**Draft Final Scope of Work for Preparation of an  
Environmental Impact Statement  
80 Flatbush Avenue  
SEQR/CEQR No. 17ECF001K**

This document is the Final Scope of Work (FSOW) for the ECF 80 Flatbush Avenue Draft Environmental Impact Statement (DEIS). This FSOW has been prepared to describe the proposed project, present the proposed framework for the EIS analysis, and discuss the procedures to be followed in the preparation of the DEIS. This FSOW incorporates revisions of the Draft Scope of Work (DSOW) and are indicated by double-underlining new text and striking deleted text.

## **Appendix A: Response to Comments on the Draft Scope of Work**

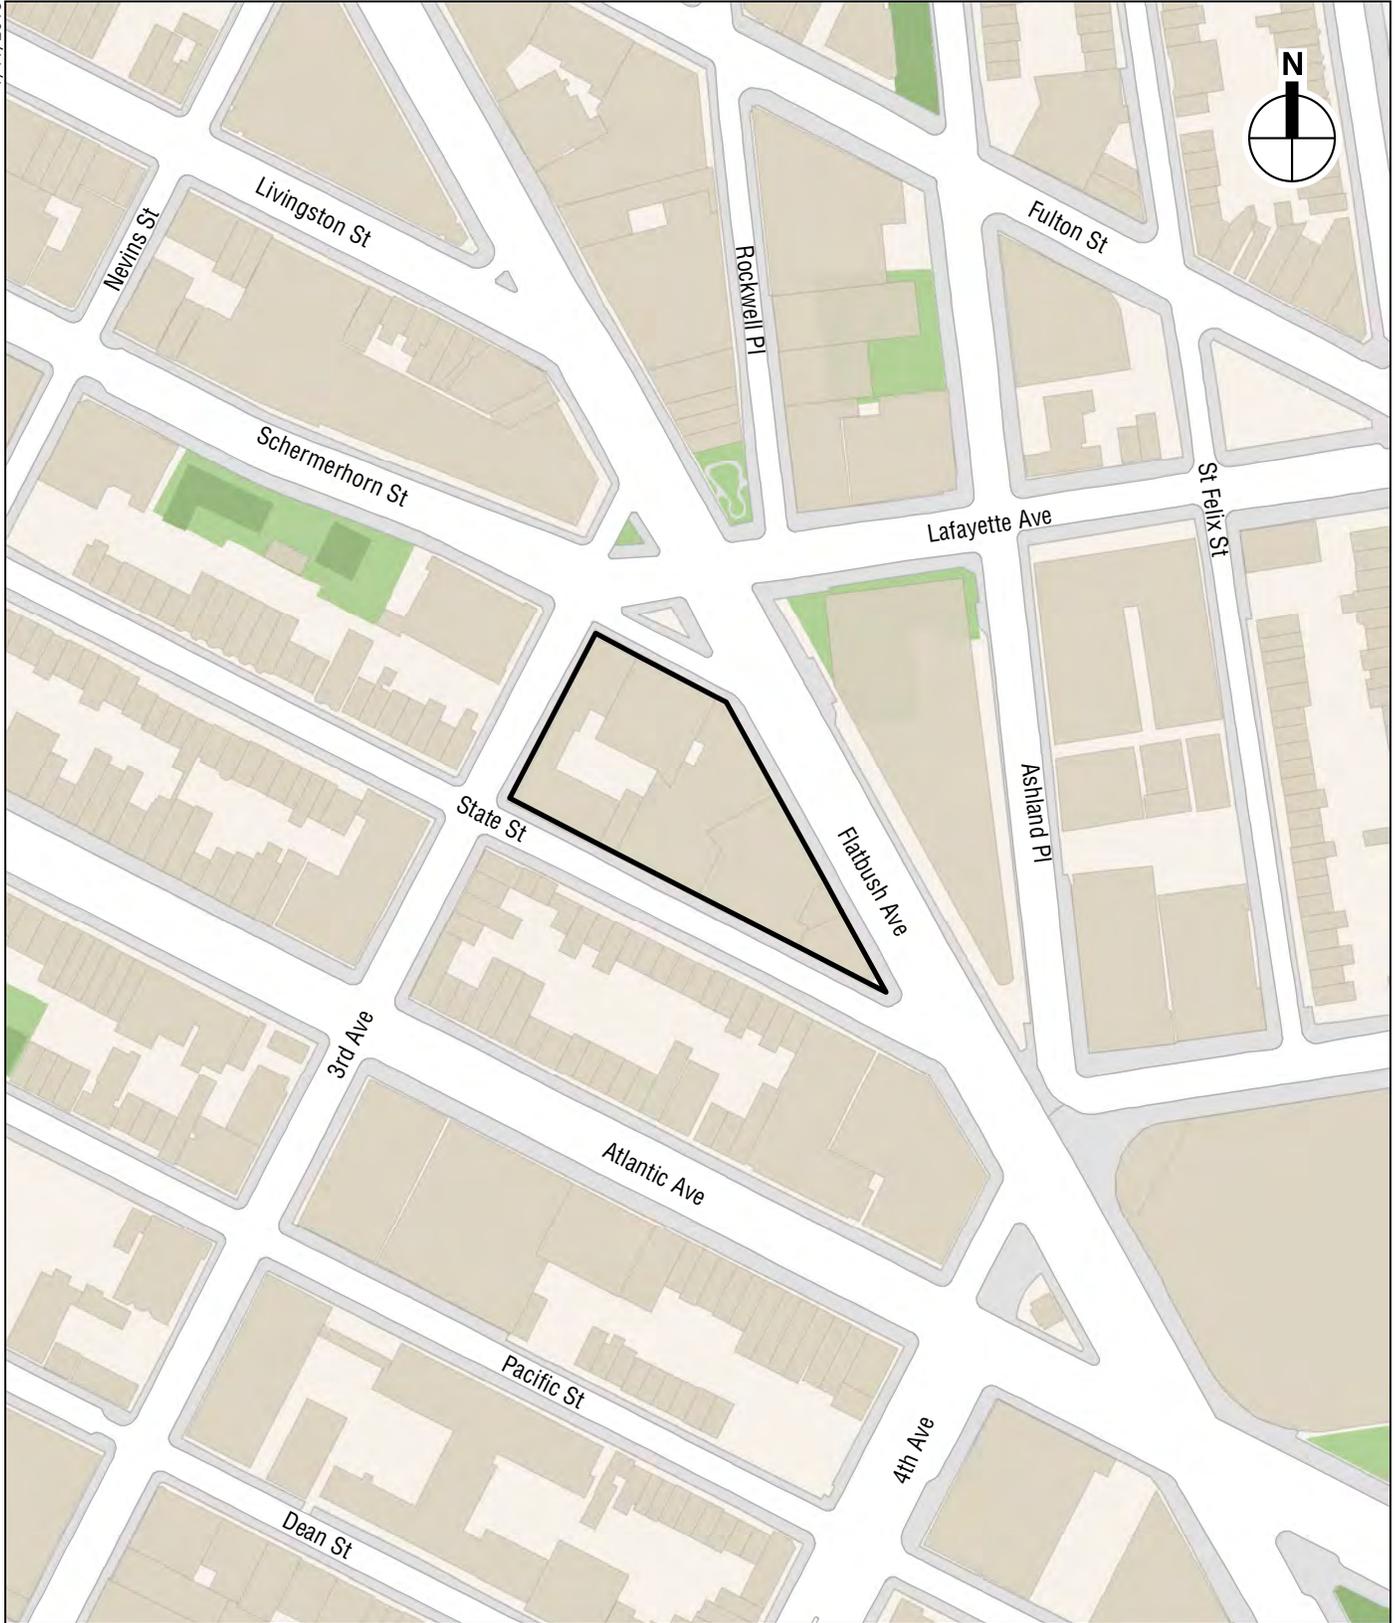
**Comment 11:** Figure 1 in the draft scope of work does not include 333 Schermerhorn Street, 300 Ashland Place and 15 Lafayette Avenue, which together contain over 1,200 apartments, nor does it map 590 Fulton Street, just beyond the 400-foot radius around the project. Brooklyn Community District 2 is a highly dynamic area and I encourage the Educational Construction Fund (ECF) and its consultants to take care in obtaining the most current data available. (3)

I note that Figure 1 in the draft scope of work does not include 333 Schermerhorn Street, 300 Ashland Place and 15 Lafayette Avenue, which together contain over 1,200 apartments, nor does it map 590 Fulton Street, just beyond the 400-foot radius around the project. Brooklyn Community District 2 is a highly dynamic area and I encourage the Educational Construction Fund (ECF) and its consultants to take care in obtaining the most current data available.

**Response:** The figures in the DEIS will include updated depictions of the recent development in the area. As noted in the Draft Scope, future baseline conditions will include other planned and approved projects.
